FORD:

1999-2004 Super Duty F-53 Stripped Chas.

This article supersedes TSB **02-09-09** to update the Service Procedure and affected model years.

TSB 04-24-22 (Continued)

Figure 1 - Article 04-24-22

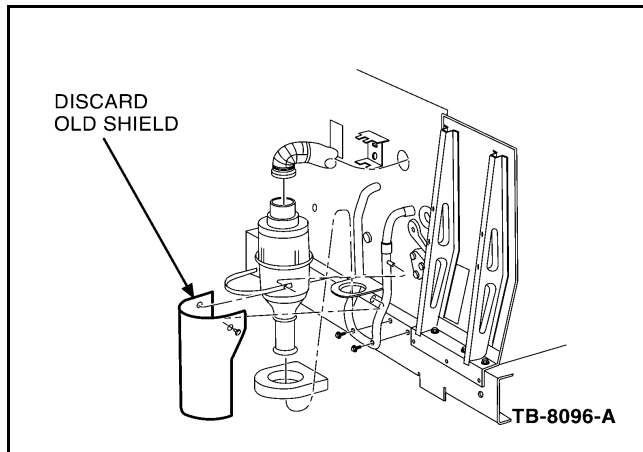
1. Remove and discard existing shield. 2002-2004 model year vehicles are equipped with a long shield (Figure 1) and 1999-2001 model year vehicles are equipped with a short shield (Figure 2).

Figure 3 - Article 04-24-22

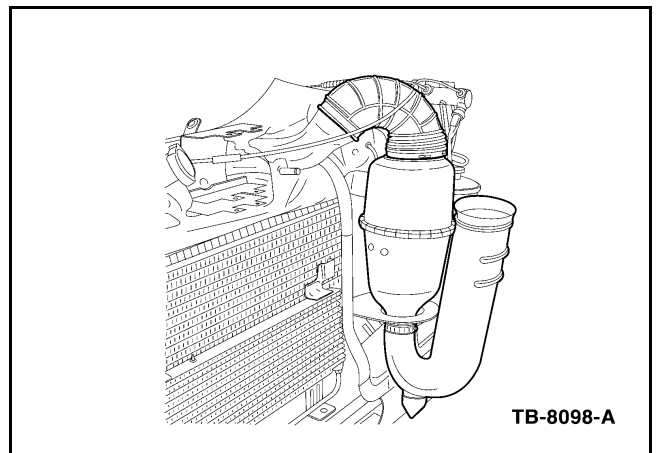
2. Remove and discard the existing air inlet tube. To remove, grasp the air inlet tube at the bottom of the air cleaner assembly and pull downward.
3. Remove and discard existing retention strap.
4. Install revised air inlet tube into the bottom of the air cleaner assembly and secure with revised strap (Figure 3).
